**Re: 1496
Herget Variance – Infiltration Trench**

**Re: 1496
Herget Variance - ADDENDUM**

**Re: 1496
Herget Variance**

Re: 1066
Herget Site Plan

HERGET RESIDENCE
REVISED MITIGATION SWM CONCEPT
1.27.09
1" = 10'
L.S. U.C.

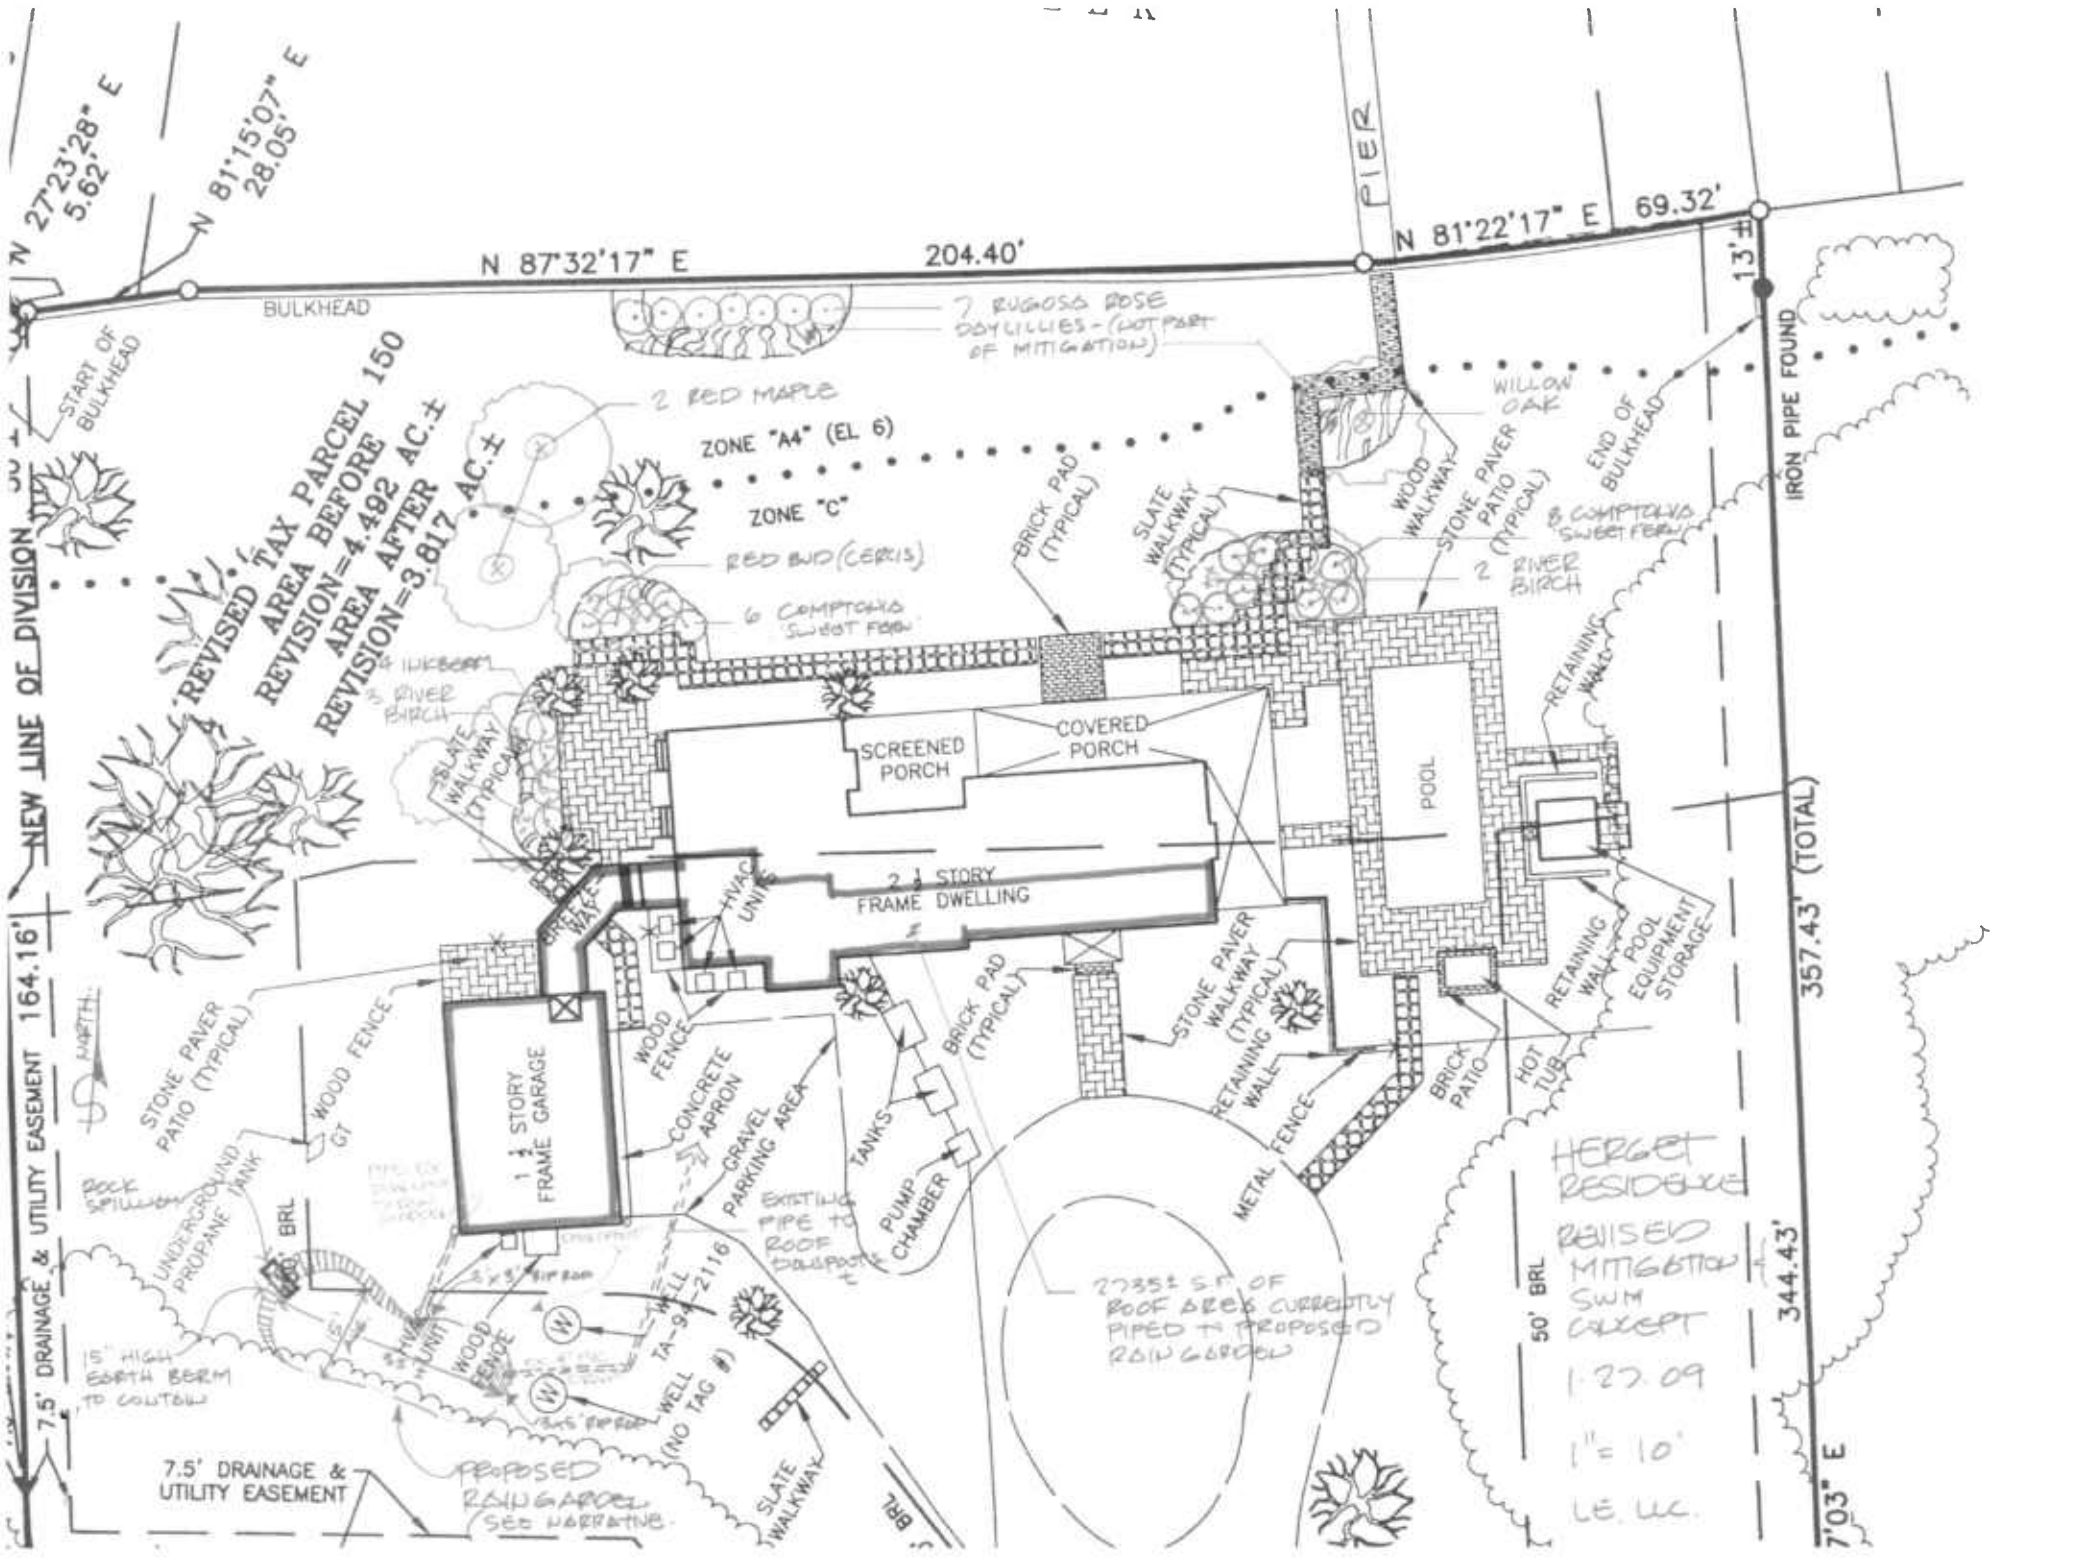
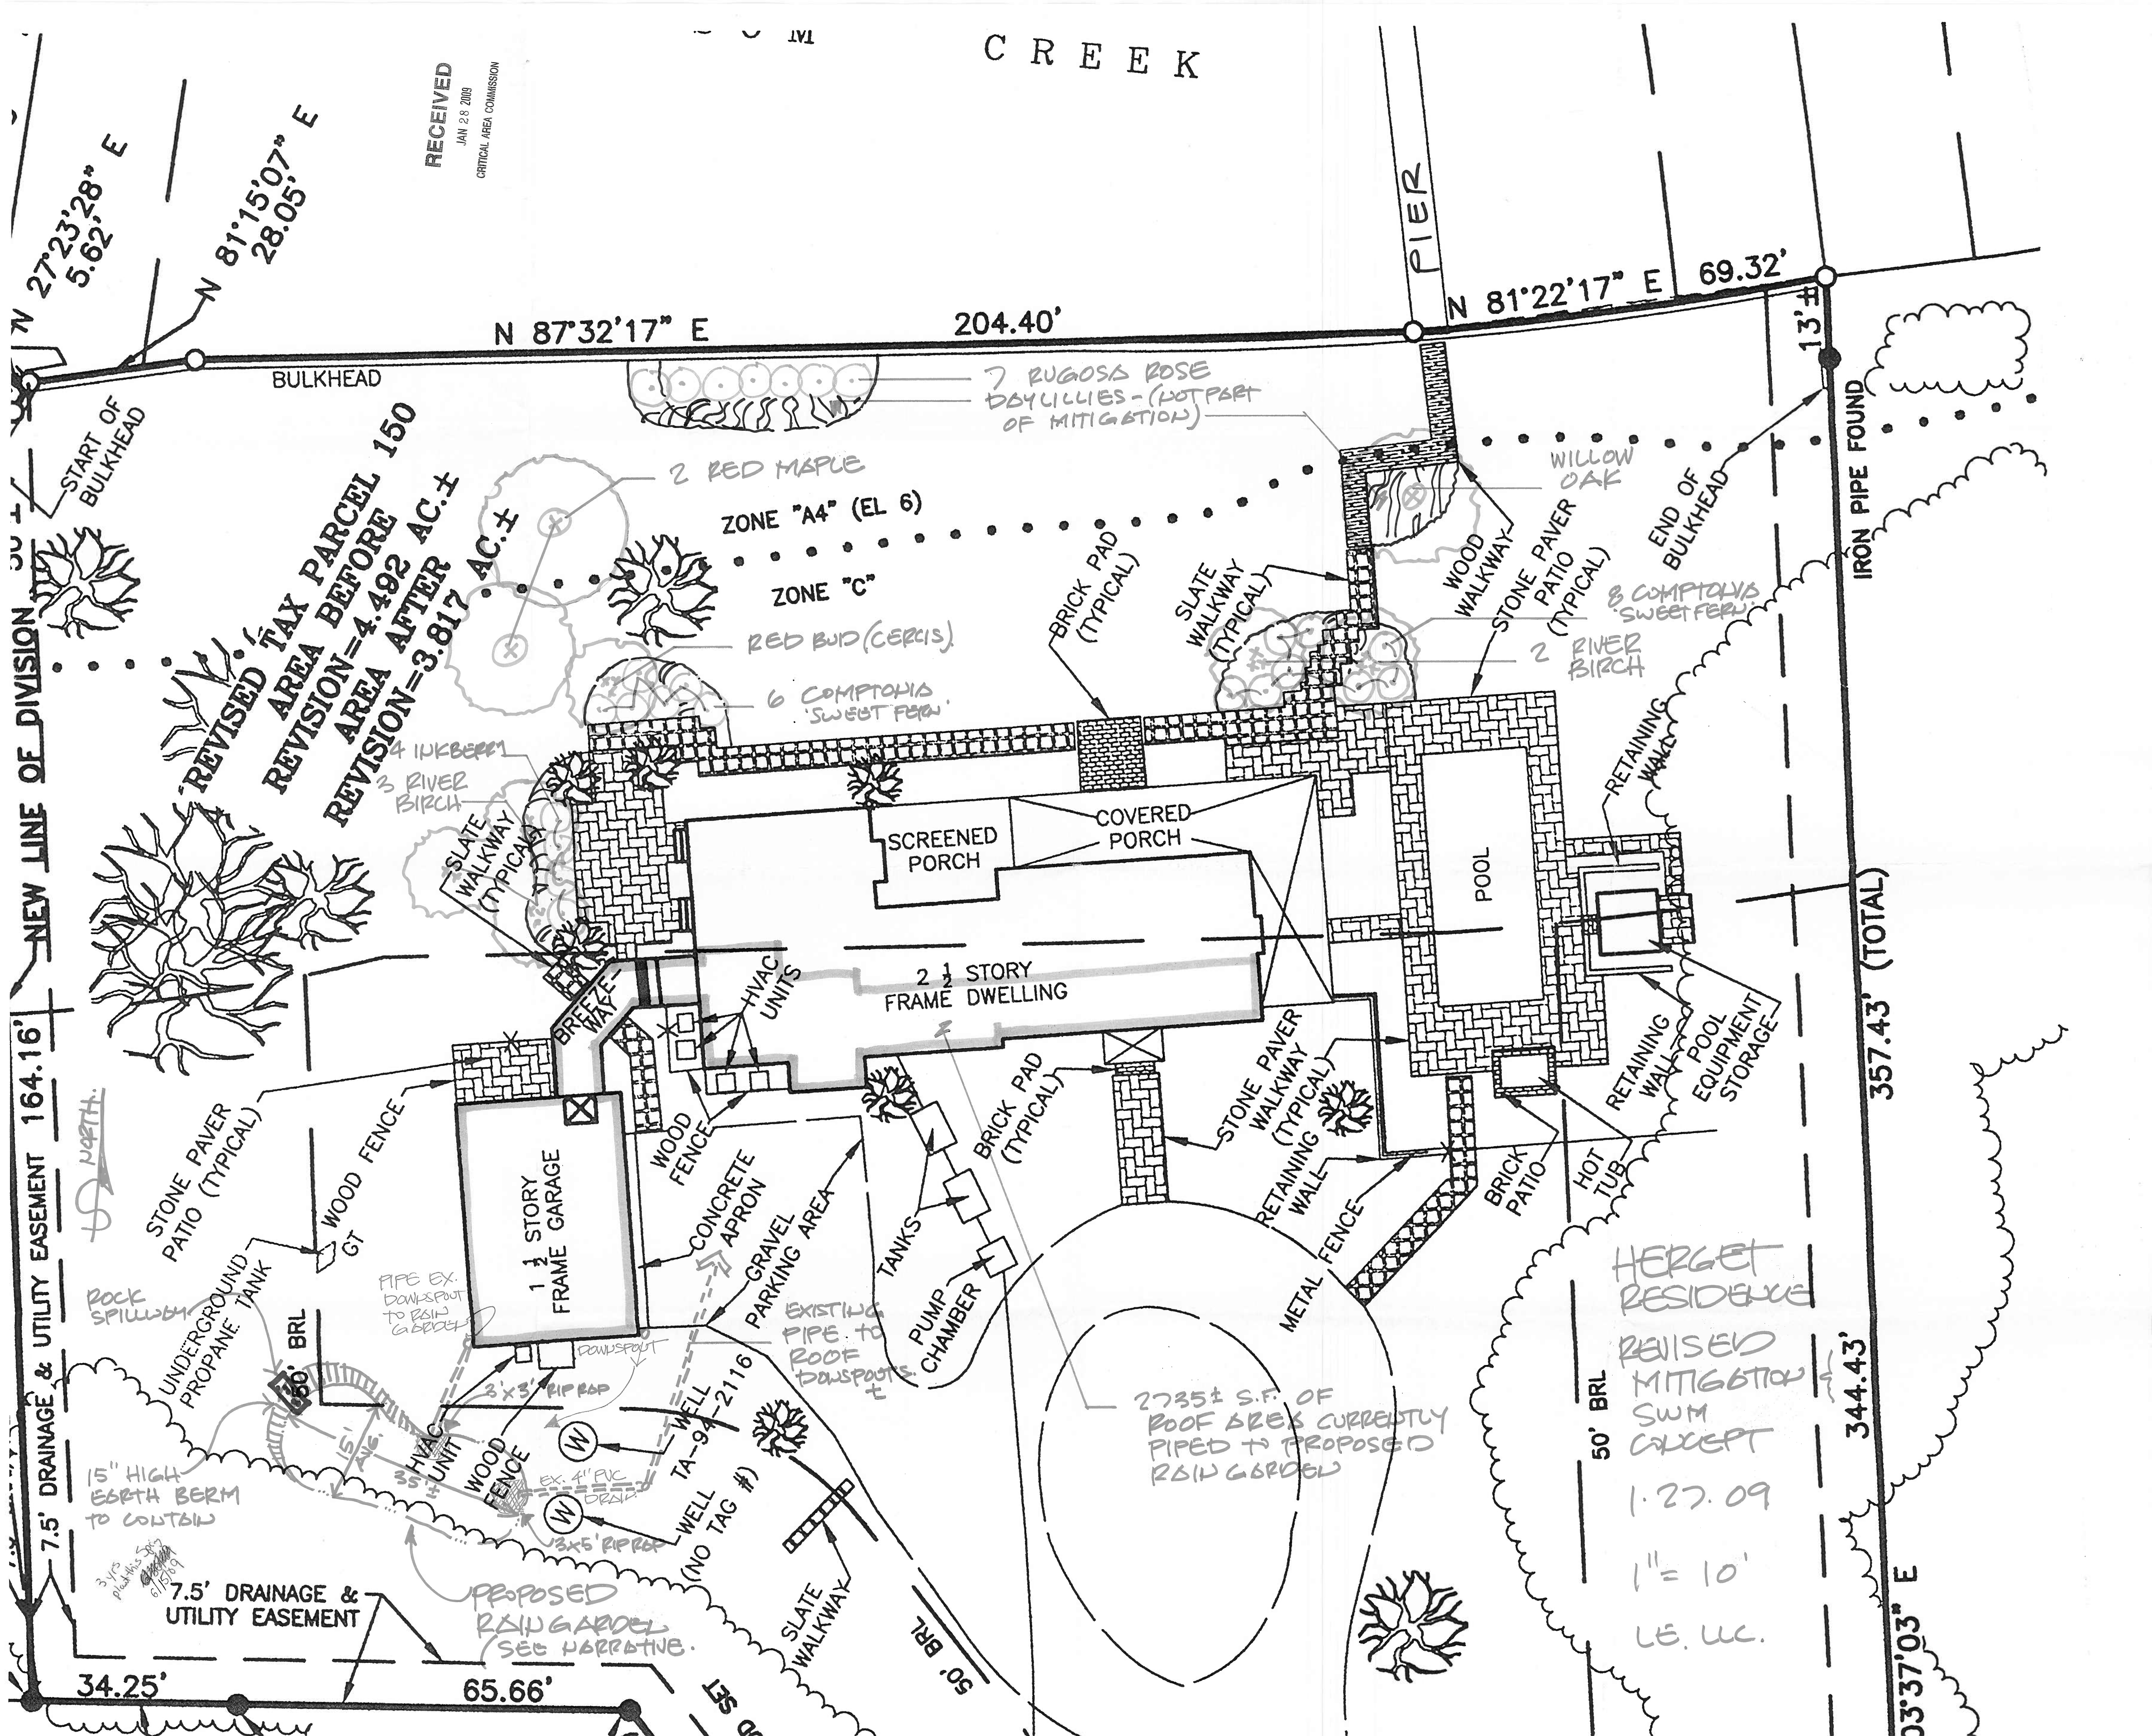
Dr, Kelly, on behalf of the Herget's, I enclose a revised mitigation and swm concept plan for Critical Area staff review and comment. It reflects the discussions we had last Friday related to plant location, type and swm objectives. The following narrative outlines some of the specifics. Please review this concept and let me or the attorneys know that the concept is acceptable or acceptable with specific changes. From there, I will finalize the plan to whatever format is necessary for the settlement agreement.

A. 3:1 Mitigation Plantings- 9 trees and 25 shrubs located both sides of house between water and paving areas subject of Variance. Trees shall be minimum 2" caliper or equivalent if multi-stem and the following species: Quercus phellos (willow oak), Betula nigra 'Heritage' (river birch), Acer rubrum (red maple) and Cercis canadensis (red bud). Shrubs shall be minimum 3 gallon size and include Comptonia peregrine (sweet fern), Ilex glabra 'Shamrock' (inkberry) and Rosa rugosa (rugosa rose). Additional daylilies or other perennials will fill in bed lines as shown, but these plants are not part of required mitigation.

BUFFER LOT
 COVERAGE
 OFF-SET PL.
 CONCEPT
 11-25-08

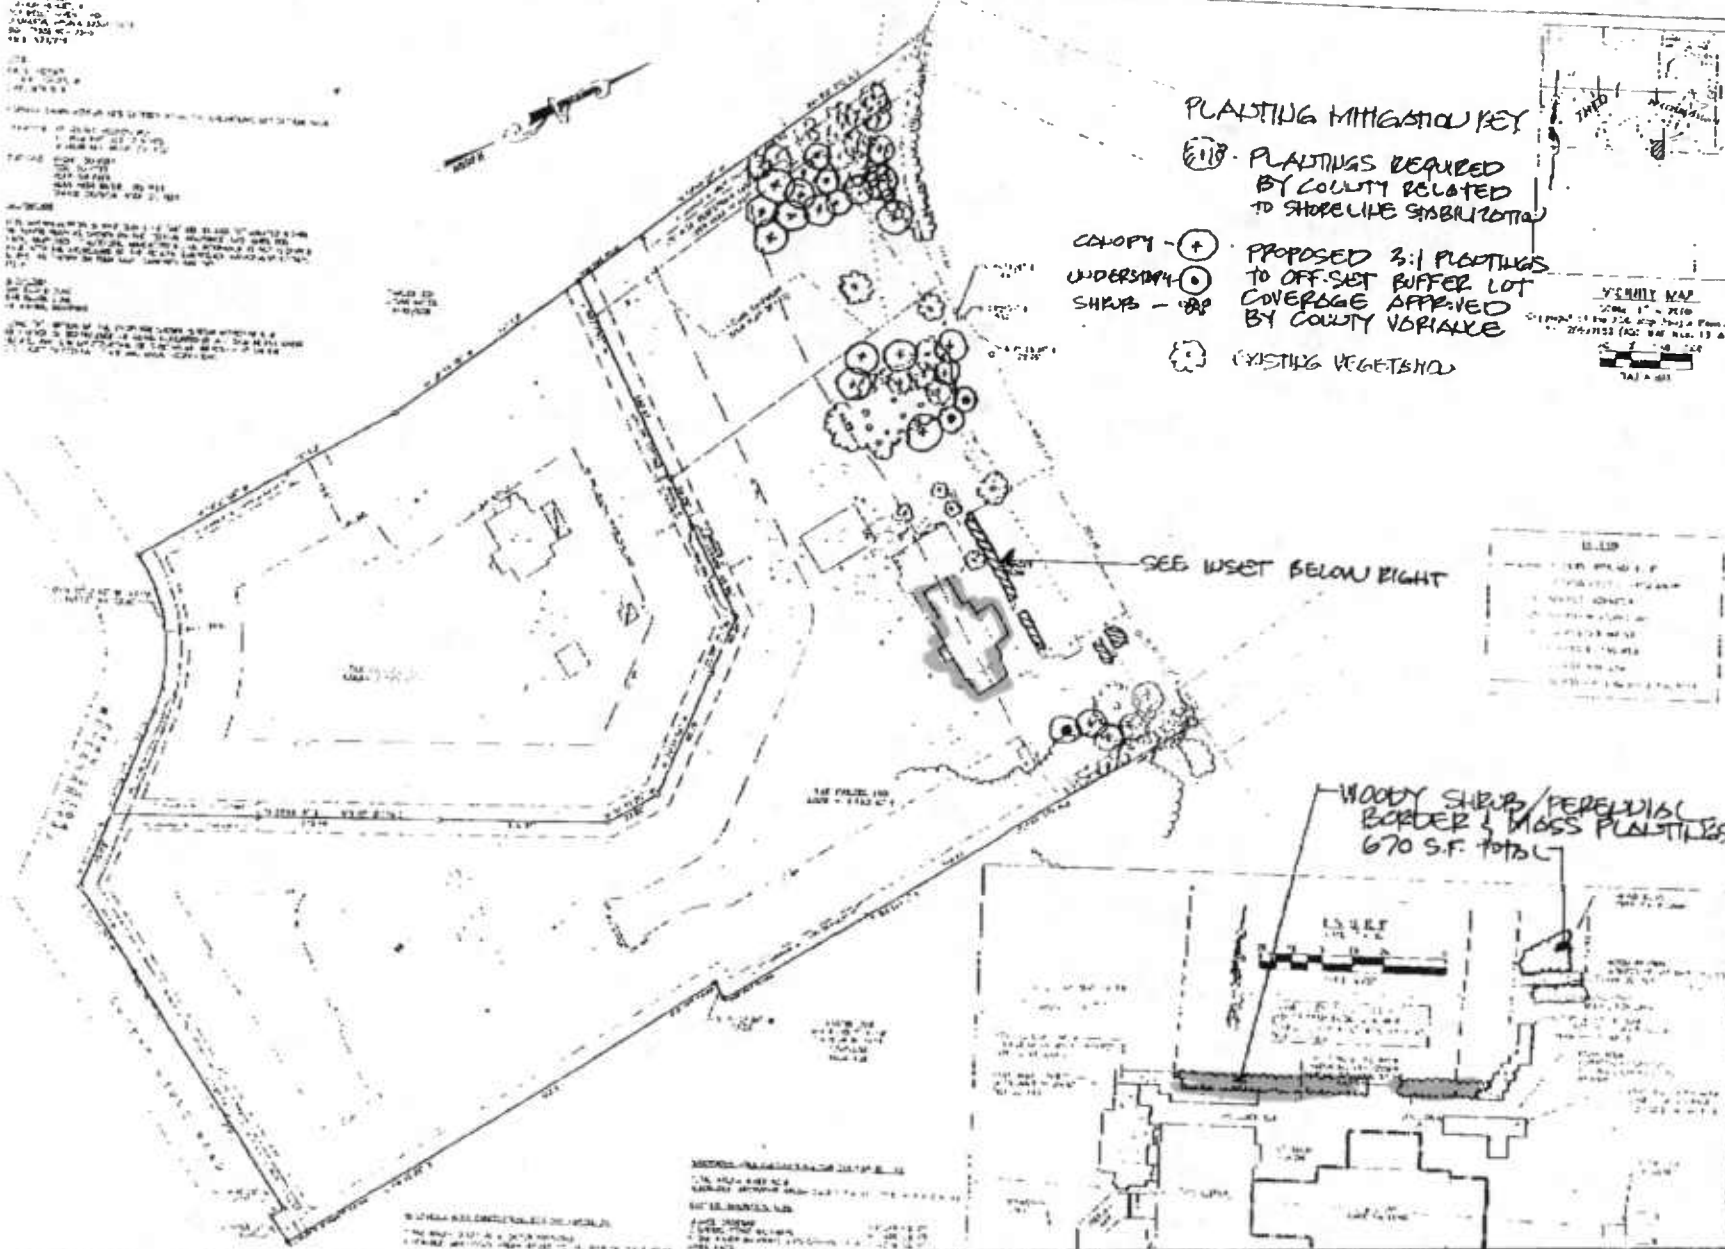
On behalf of Phil and Lisa Herget, I enclose a Buffer Planting Concept designed to off-set the impacts of impervious surfaces (lot coverage) constructed in the 100' Buffer and approved by the Talbot County Board of Appeals. We discussed this planting concept several weeks ago and at that time you outlined we should "consider" a 3:1 planting ratio to offset the lot coverage and "consider" additional plantings to off-set storm water run-off impacts and improve water quality.

| 1. Off-Set Plantings (3:1 ratio) for Buffer Lot Coverage | |

At 3:1 ratio = 3330 sq ft of planting. At 400 stems per acre with approximately 25% shrub and 25% understory trees, this planting comprises 30 stems total, or 7 shrubs, 7 understory trees and 16 canopy or larger evergreen type trees to be planted in the Buffer. This planting (red on attached plan) is proposed for areas adjoining other Buffer plantings (green on attached plan) required previously and separately by the County for shoreline stabilization replacement plantings. Species proposed for this planting are Canopy Trees- Red Oak, Willow Oak and Loblolly Pine; Understory Trees- Fringe Tree and Amelanchier; and Shrubs- Virginia Sweetspire.

2. Storm Water Management Off-Set Plantings- you indicated a preference for a "plant based" solution in lieu of a rain garden or bio-retention solution that requires grading and consequently a Variance for disturbance in the Buffer. To that end, we propose 670 sq ft of woody shrub/perennial border plantings along the length of the paving stone walkway (except for grassed pedestrian opening at brick landing) and additional massed woody shrub/perennial mixed beds around wood walkway section all designed to capture storm run-off from the paving stones and wood walkway, and through absorption and infiltration reduce and treat potential storm run-off generated by the lot coverage in the Buffer.
